SUBJECT: Forwards description of drywell/torus vacuum breaker mods,
 per 830523 commitment to submit plant-unique calculations &
 schedule in response to Generic Ltr 83-08.

ENCLOSURE
DRY/WELL TORUS VACUUM BREAKER MODIFICATIONS
BROWNS FERRY NUCLEAR PLANT

FIGURE 3.1
 Drywell/Wetwell Vacuum
 Breaker Modifications

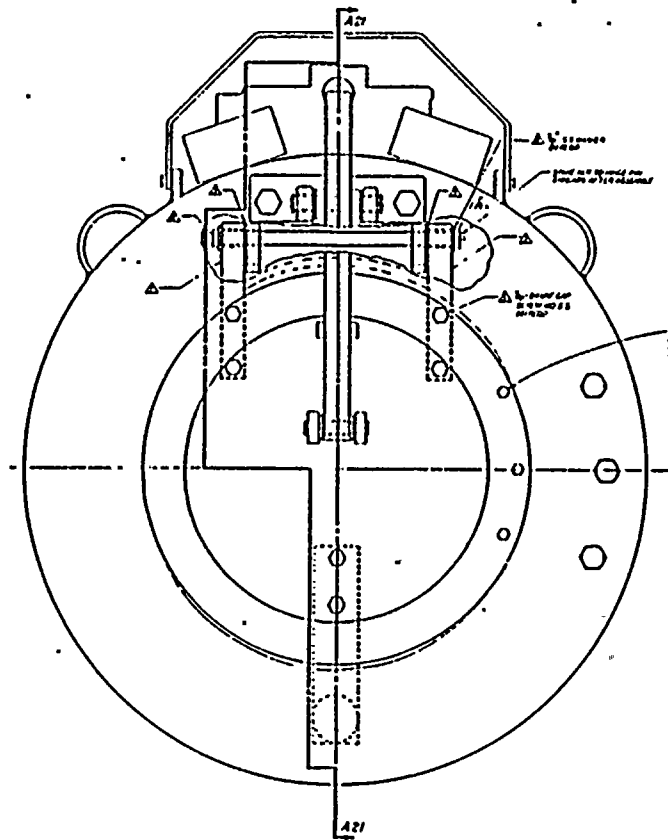
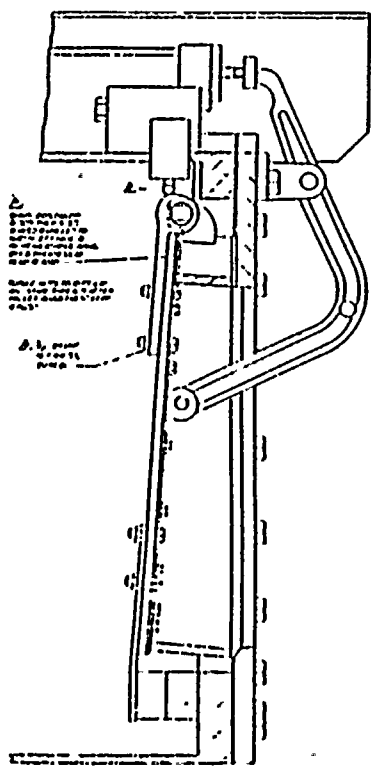
Design modifications are being made to the 18-inch GPE vacuum breaker valves in order to comply with criteria resulting from the dynamic analysis. The following is a summary of the modifications which are depicted in figure 3.1.

Each existing nodular iron hinge arm was replaced with one made of type 316 stainless steel. This material was chosen for its enhanced corrosion resistance characteristics as well as increased strength and ductility.

The existing 303 stainless steel pins were replaced with 410 stainless steel in order to provide greater strength and hardness.

The threaded end of the pin was staked after assembly to prevent loosening of the retaining nut.

The existing teflon sleeved eccentric aluminum bushing was replaced with a concentric solid brass bushing. This material was chosen for its self-lubricating and corrosion resistance properties. Also, the pin-

bushing combination affords maximum resistance to galling. The alignment adjustment capability afforded by the eccentric bushing is now provided by shimming under the hinge arm to obtain pallet-to-seat alignment within 0.003 inch.

The existing mild carbon steel bolts were replaced with bolts made of ASTM A193 GR B6, which is a 410 stainless steel material.

Using loads from the dynamic analysis, bolting stresses were calculated and found to be much less than ANSI/ASME B31.1 (1980 Edition) allowable stresses for this material. An initial torque was specified which is sufficient to provide for a friction fit between the pallet and hinge arm which will not allow slippage. The threads were staked after torquing to prevent loosening.

The existing gasket retaining ring threaded fasteners were secured after assembly by staking the threads. In addition to this, existing assembly procedures require that the gasket be secured to the pallet using plant approved gasket cement.
